Access Compliance Report

Public Rights-of-Way

(Curb Ramps)

Intersection ID: 29354	Main Street: OSAGE_CR	Cross Street: TETON_TL	Location: SE
ADA ID: E49388E9780A	Ramp Type: BlendTrans1	Initial Pass/Fail: Pass	Overall Compliance: No
		Severity Score: 7.75

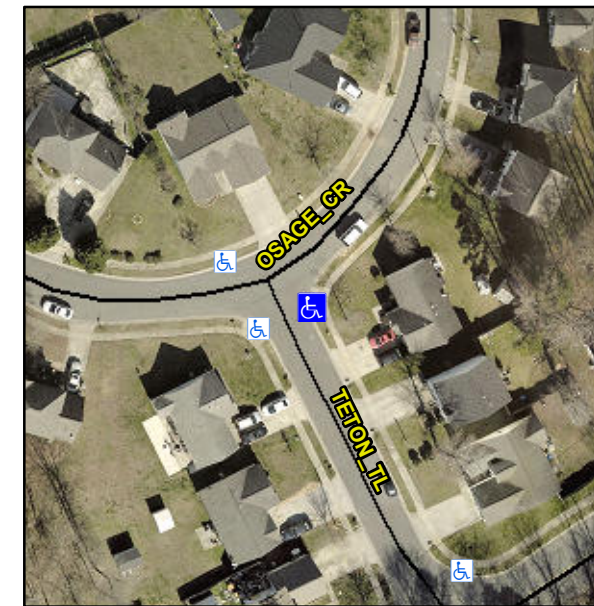
CURB GAP 2.0

Not Found, R304.5.3, R304.2.1, R304.2.2-Perp, R304.3.2-Para, R305.1.4, R305.2, R304.5.4

Remove & Replace Curb Ramp With Two New Directional Ramps or Equivalent. Remove & Replace Gutter.
